SOURCE INFORMATION
GROUND WATER

WELL NAME Holcomb Blvd 706

CONTRACT NO 81-C-1644		TRANSMITTAL NO 149-A	DATE 3-14-86
FROM CONTRACTOR Harry Pepper & Associates, Inc.		PROJECT TITLE AND LOCATION Holcomb Blyd Water Treatment Plant	
TO Henry Von Oesen & Associates, Inc.		MCB, Cp Lejeune, North Carolina

RE: N62470-81-C-1644
Expansion of Holcomb Blvd
Water Treatment Plant
Camp Lejeune, NC 28542
Well # 8

WELL #8

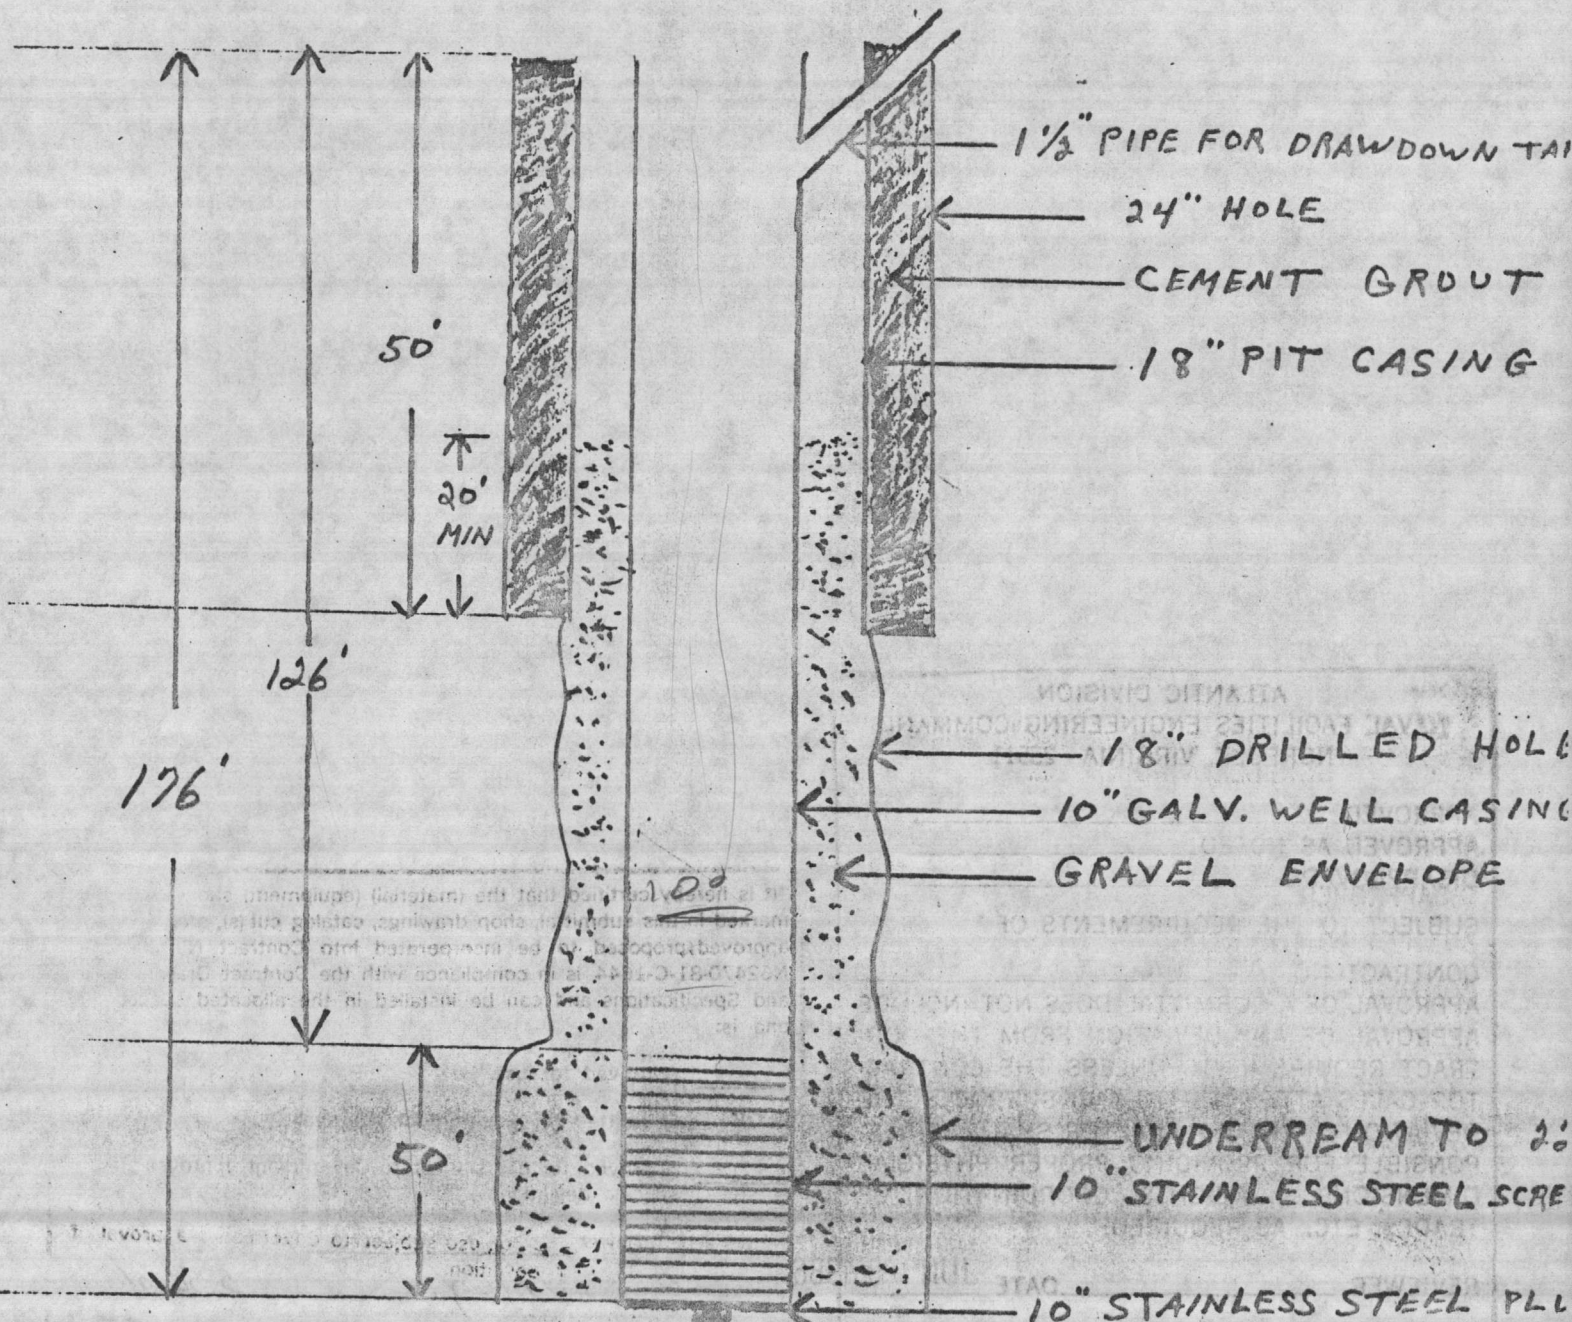
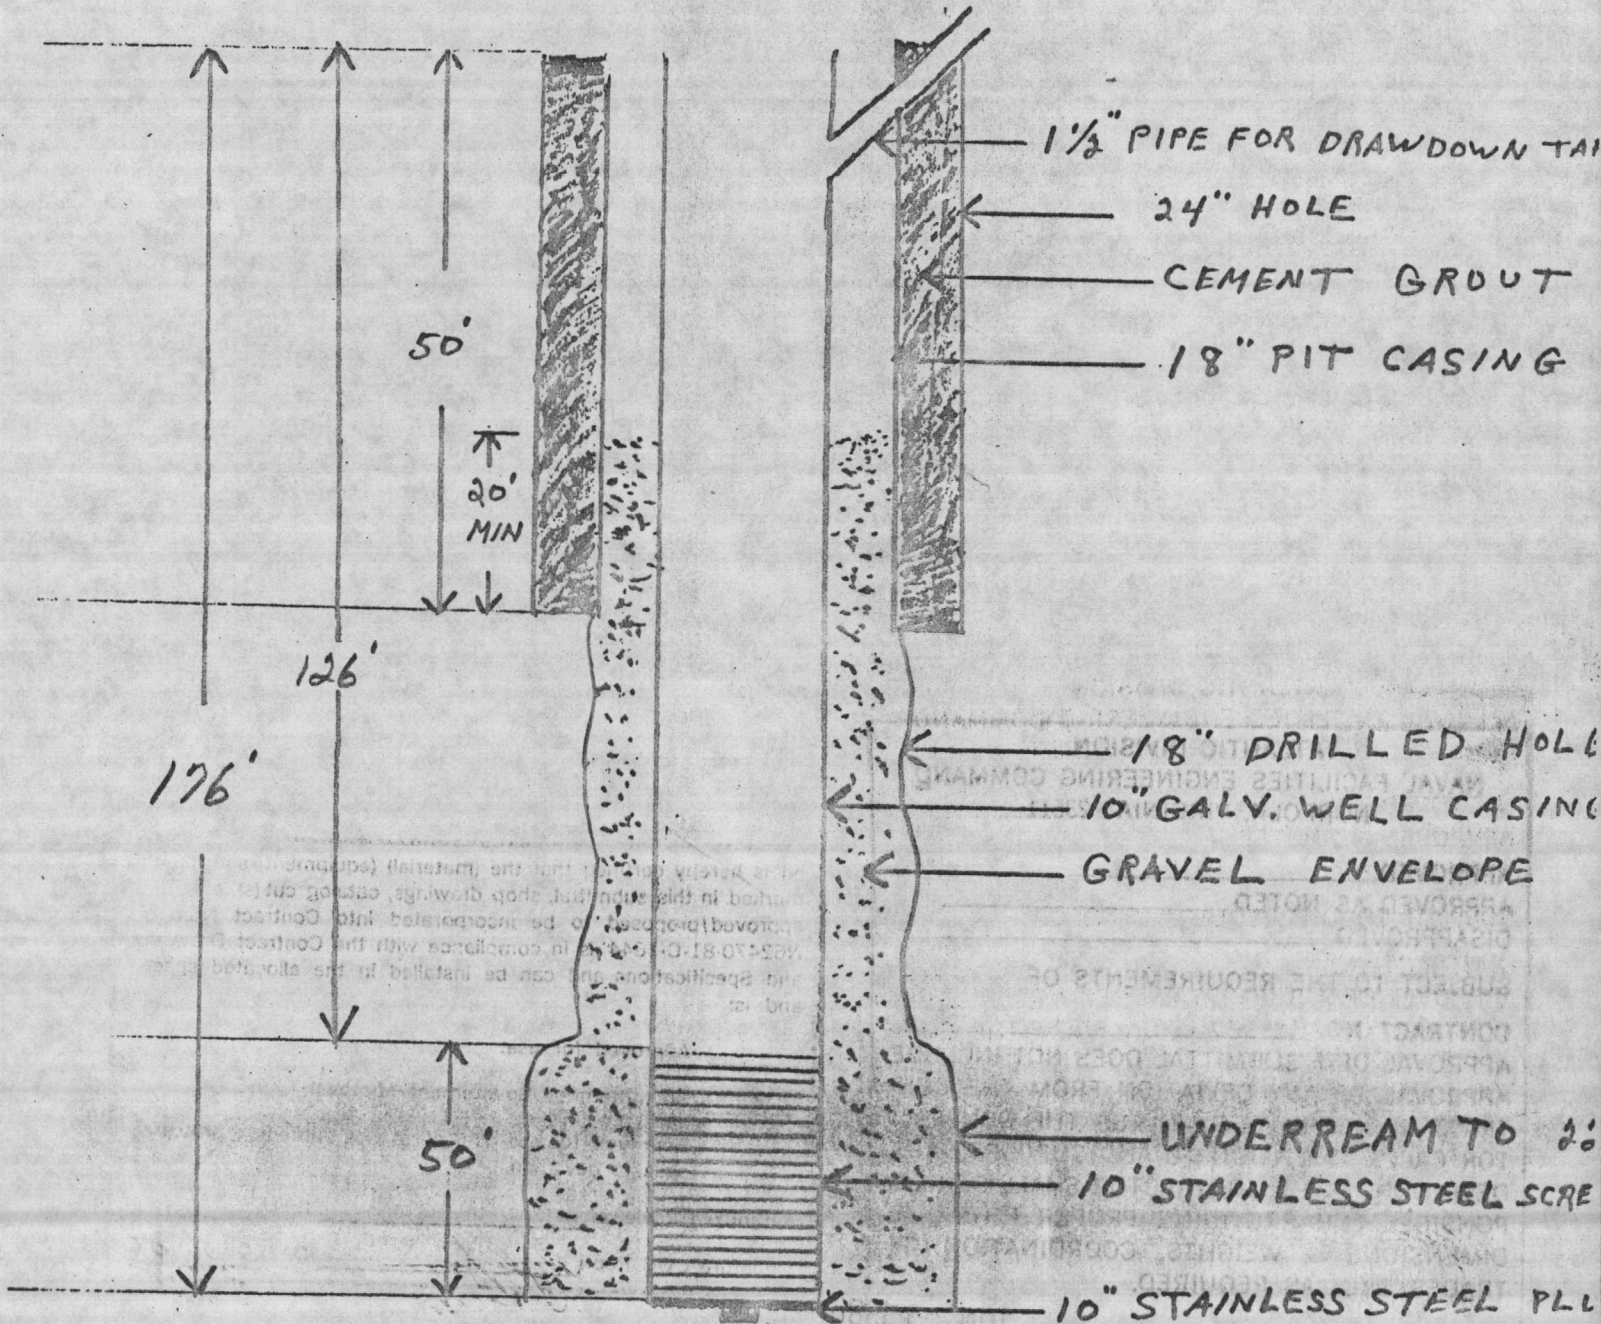
An Additional twenty (20) feet of screen was added.

This Shop Drawing replaces shop drawing previously submitted. See Transmittal # 149-A, dated 3-14-86.
